Transmitter equalization feedback and MDIO control

(In support of comment #i-9)

Adee Ran
Intel Corporation

Figure 83D-5 depicts the components of the CAUI-4 chip-to-chip link and the registers used during the tuning procedure.

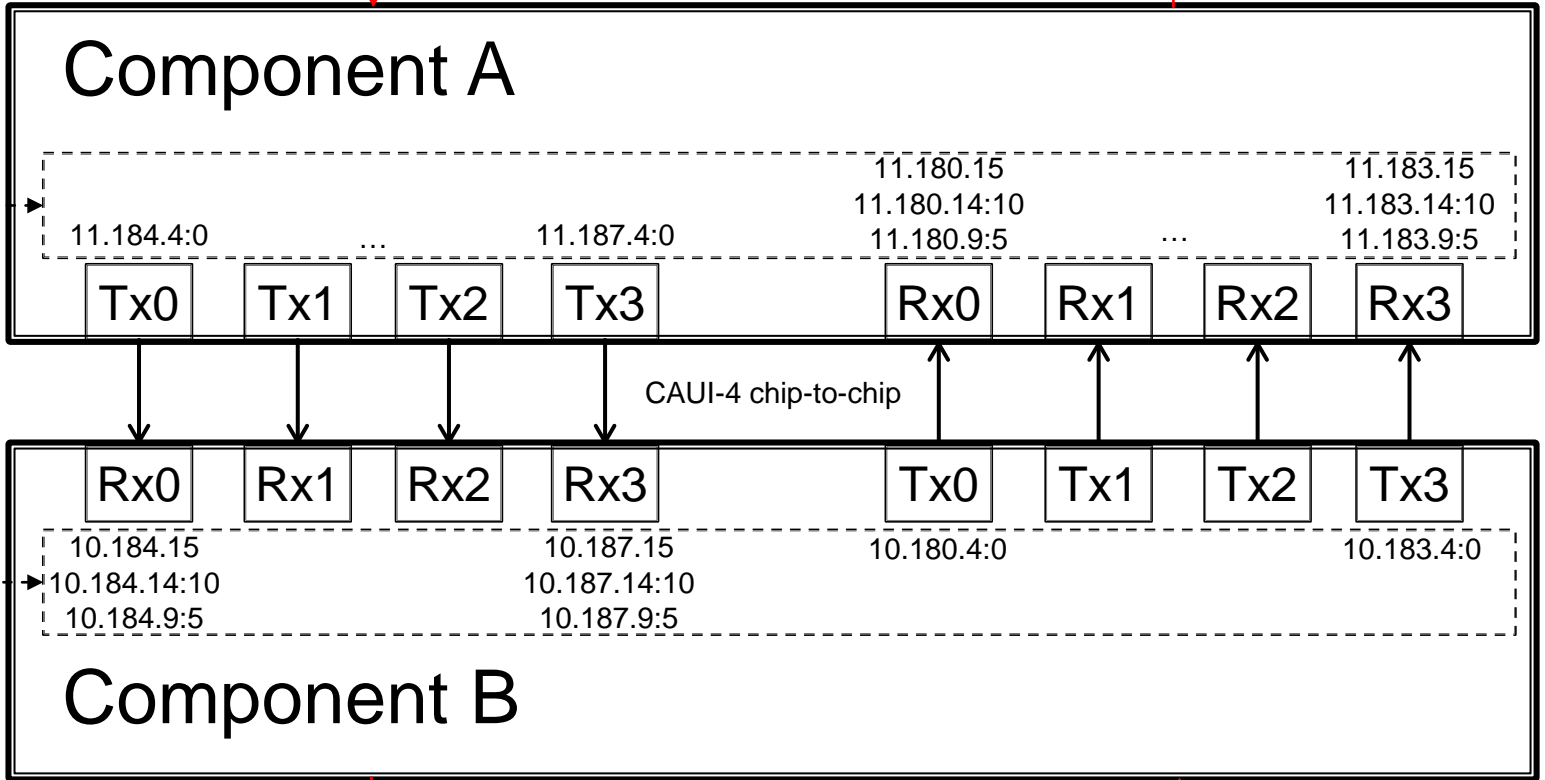
In this example, two components, A and B, are connected by a CAUI-4 chip-to-chip link, such that A is closest to the PCS and B is closest to the PMD. Clause 45 MDIO is implemented by both components, with component A at device address 11 and component B at device address 10. Transmitter equalization feedback is implemented by either component A, component B, or both. One Station Management (STA) controls both components.

(insert Figure 83D-5 here)
